**REQUEST**

Current Zoning: R-5 (single family residential) & R-22MF (multi-family residential)  
 Proposed Zoning: UR-2(CD) (urban residential, conditional)

Approximately 1 acre located near the SE intersection of Parkwood Avenue and Hawthorne Lane in the Plaza Midwood community.

**SUMMARY OF PETITION**

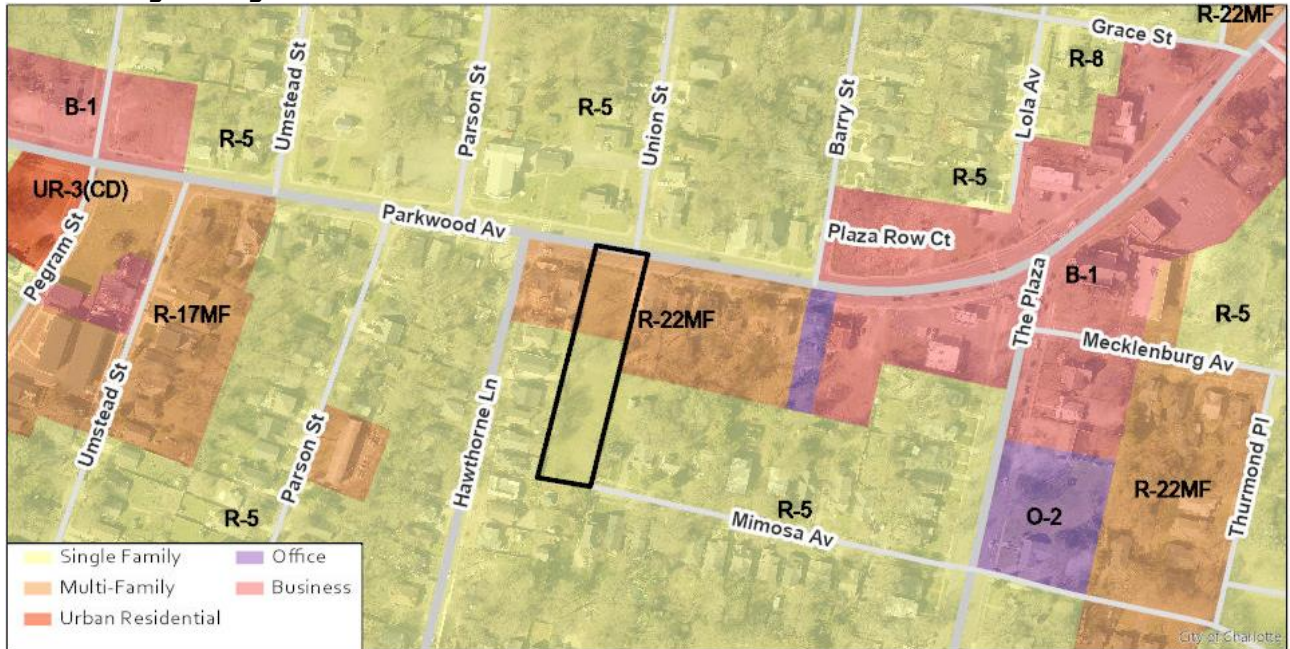
- ~~1. Revise the driveway to Mimosa Avenue to meet Charlotte Land Development Standards Manual for two-way circulation since it is a shared driveway.~~ ADDRESSED

- ~~2. The petitioner should present a design that is more aligned with the future land use of the parcel and reflective of the surrounding residential context that is proximal to the site along Mimosa Avenue and Parkwood Drive. These changes should reflect a reduction in density, height, and overall impervious area of the proposal. The proposed surface parking lot is not supported in any form.~~ RESCINDED. The petitioner has added pervious pavers to a portion of the surface parking lot. A reduction in height has also been provided.

- ~~3. Coordinate with Charlotte Fire to resolve the required provision of an approved turnaround.~~ ADDRESSED
